# UNITED STATES PATENT AND TRADEMARK OFFICE

APPLICATION NO.	FILING DATE	FIRST NAMED INVENTOR	ATTORNEY DOCKET NO.	CONFIRMATION NO.
10/826,272	04/19/2004	Kazuhiro Fujii	SN-US045038	9912
22919 7590 11/15/2007 GLOBAL IP COUNSELORS, LLP 1233 20TH STREET, NW, SUITE 700 WASHINGTON, DC 20036-2680			EXAMINER LUONG, VINH	
			ART UNIT 3682	PAPER NUMBER
			MAIL DATE 11/15/2007	DELIVERY MODE PAPER

# Office Action Summary

# ATTACHMENT

FIG. 2 BENT SECTION

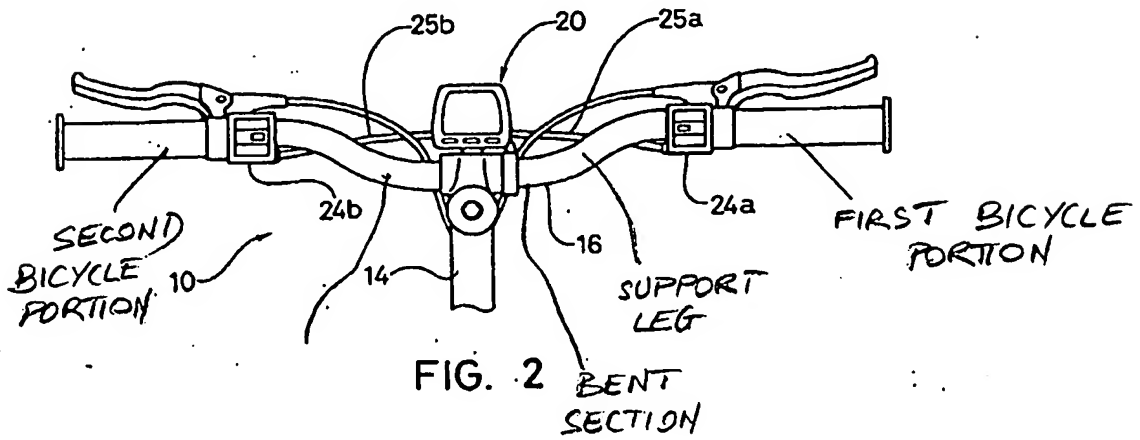
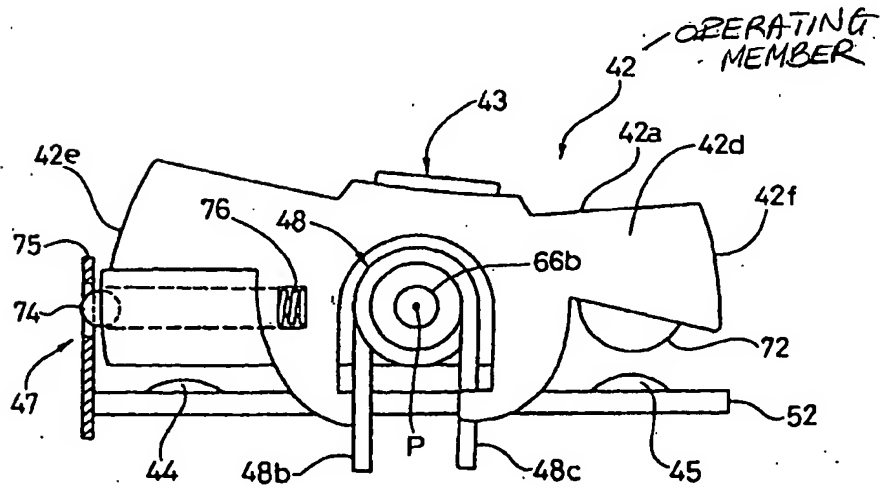
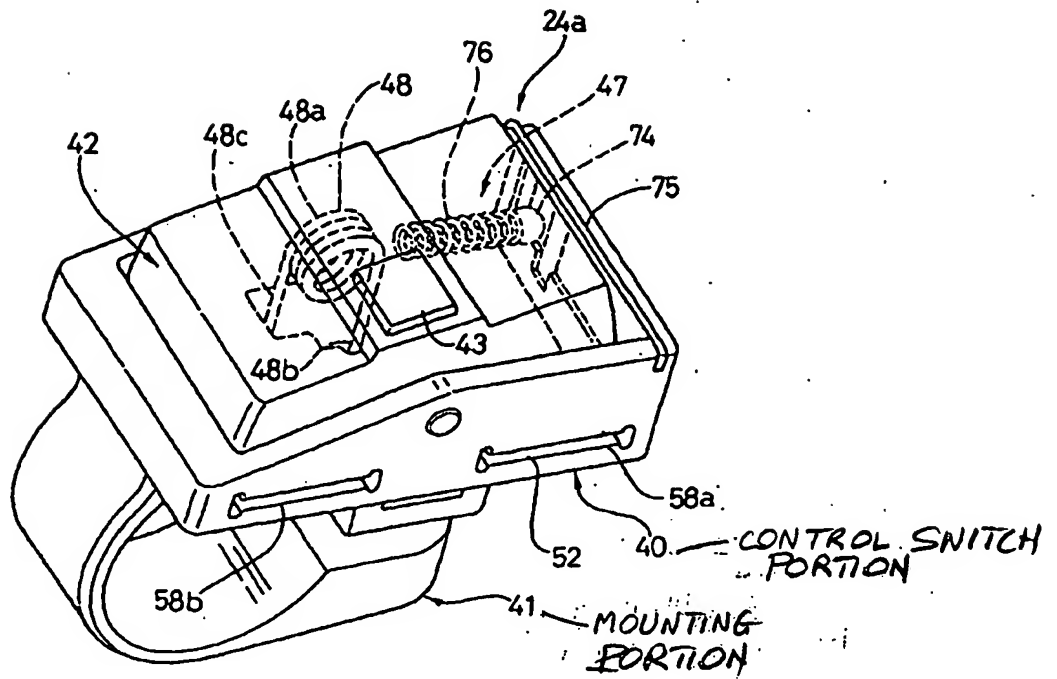
a first shift control device 24a (FIG. 2) including a first mounting portion 41 having a first tubular clamping member 41 (see Attachment hereinafter “Att.”) configured to be selectively clamped onto a bicycle handlebar 16 (FIG. 2) and a first electrical shift control switch 40 attached to the first tubular clamping member 41 of the first mounting portion 41; and

Regarding Claim 13, the first mounting portion 41 includes a band section (FIG. 9 of Att.) and a computer support leg 16 (FIG. 2 of ) extending from the band section, and the bicycle computer unit 20 is attached to the computer support leg 16 of the first mounting portion.

Regarding Claim 14, the computer support leg 16 includes a bent section (FIG. 2 of Att.) such that the bicycle computer unit 20 is longitudinally offset from the band section (FIG. 9 of Att.) along the first bicycle portion (FIG. 2 of Att.).
